Project	IEEE 802.16 Broadband Wireless Access Working Group < http://ieee802.org/16 >	
Title	Proposal to Adopt Relay Frame Structure Option 1	
Date Submitted	2008-11-04	
Source(s)	Jerry Sydir, Alexander Maltsev, Hongang Li, Alexei Davydov Intel Corporation Rakesh Taori, Youngbin Chang Samsung Electronics Shashikant Maheshwari, Adrian Boariu, Yousuf Saifullah Nokia Siemens Networks I-Kang Fu, Pei-Kai Liao, Paul Cheng Media-Tek Inc. Fang-Ching (Frank) Ren, Richard Li ITRI Yuqin Chen, Yang Liu, Hongyun Qu, Mary Chion ZTE Corporation	jerry.sydir@intel.com rakesh.taori@samsung.com shashi.maheshwari@nsn.com ik.fu@mediatek.com frank_ren@itri.org.tw richard929@itri.org.tw chen.yuqin@zte.com.cn liu.yang8@zte.com.cn qu.hongyun@zte.com.cn mchion@zteusa.com * http://standards.ieee.org/faqs/affiliationFAQ.html >
Re:	TGm SDD: Other IEEE 802.16m-08/040: Call for Comments and Contributions on Project 802.16m System Description Document (SDD)

Proposal to Adopt Relay Frame Structure Option 1

Figure 23 Relay Frame structure ~~option 1~~

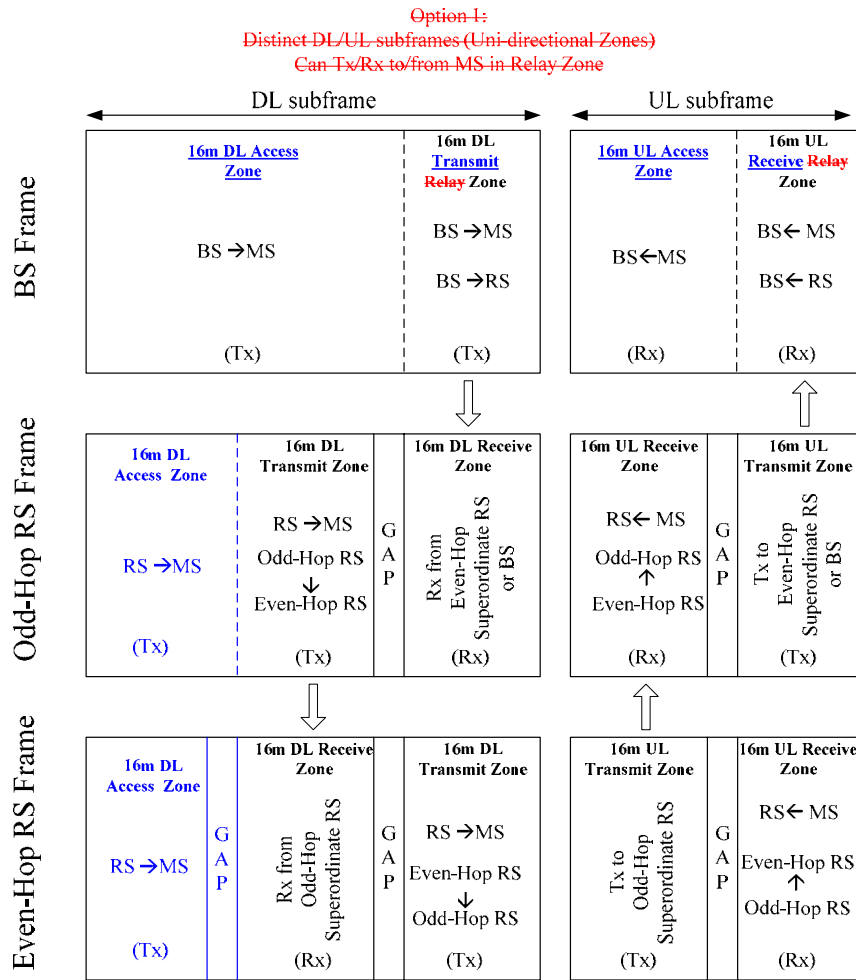
[Modify figure 25 on page 48 as indicated below]

[Modify the caption of figure 25 on page 48 as indicated below]
